Project: The Living Center

Project No.: 12029.tlc

Date: August 3, 2012

ADDENDUM # 2

1 F9/A9.1
 1/2" = 1'-0"

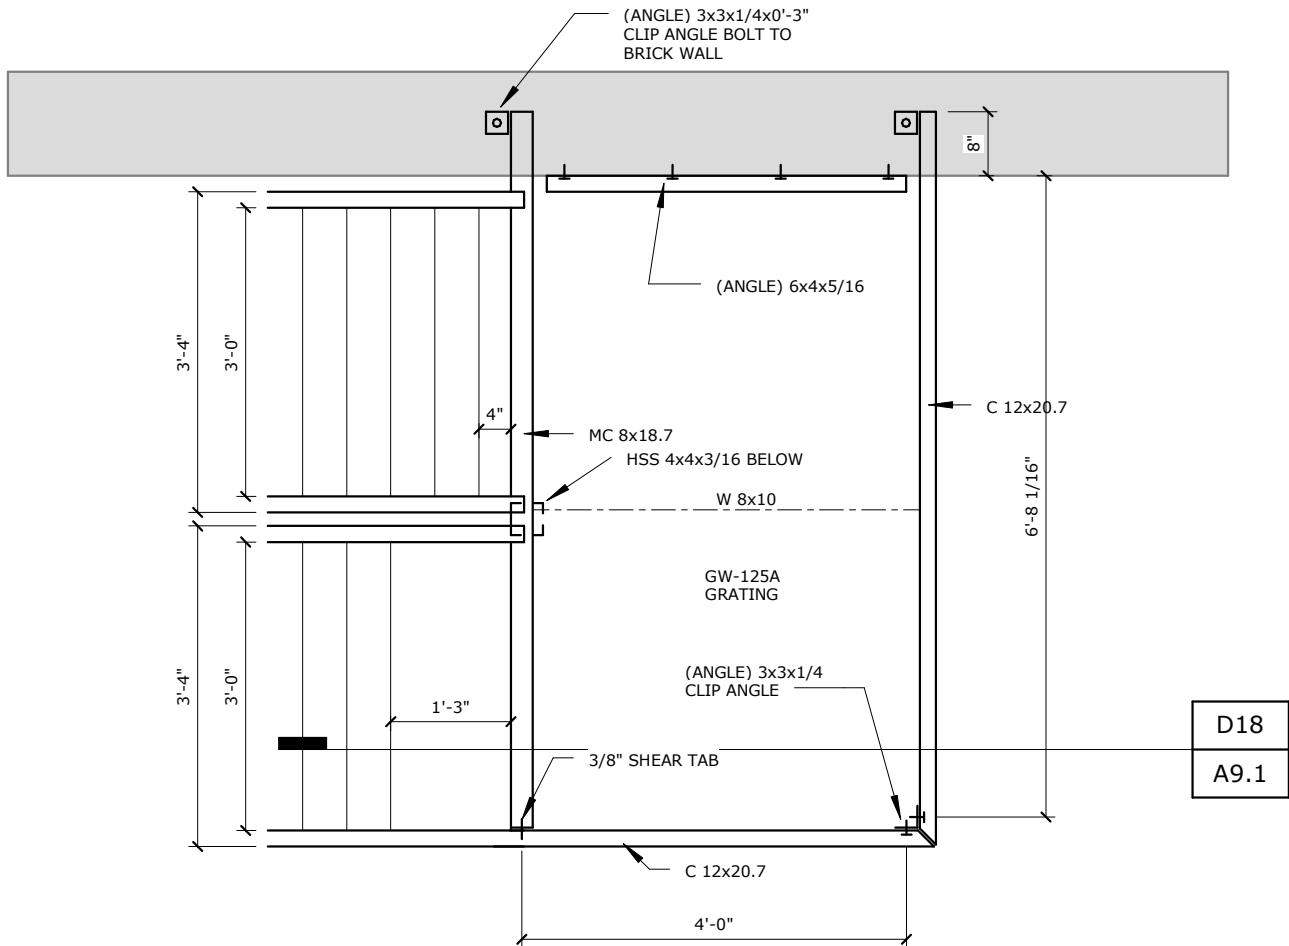
1. Sheet A9.1
 - A. Details F9 & F14
 - i. See attached showing change in width of fire escape.
2. Sheet D1.1
 - A. Detail L10, Demolition Notes
 - i. Note 2: Do not demolish wood structure supporting existing plaster ceilings. Where plaster ceilings are to be removed, wood supporting structure to remain for support of new drywall ceiling finish. Therefore, ceiling heights will remain as existing.
